## IN THE DRAWINGS

Figs. 2, 3, 4 and 5 are amended to correct errors and to conform to the specification. Replacement Sheets including amended Figs. 2, 3, 4 and 5 are included as attachments, as are Annotated Sheets showing in detail the changes made.

**FIG.3**  
 (PRIOR ART)

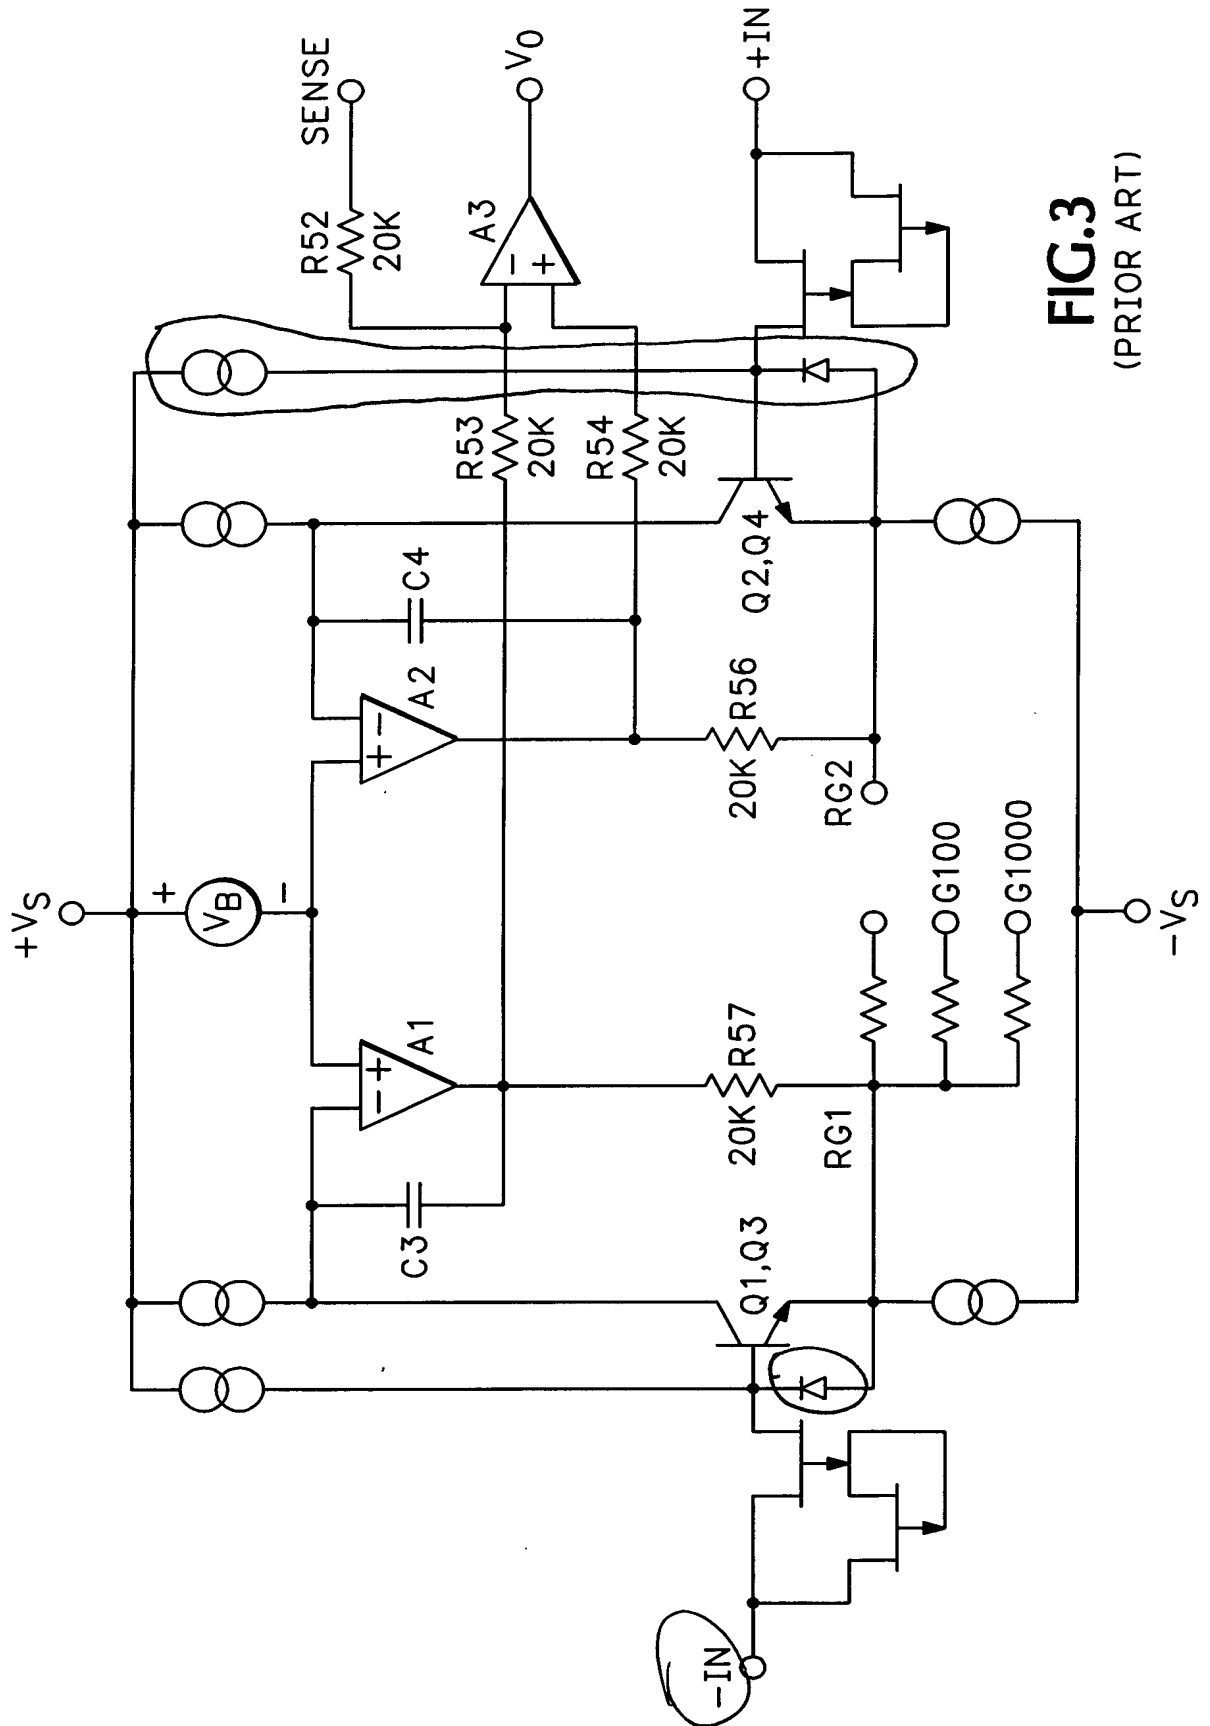
The drawings are amended to correct errors and to conform to the specification.
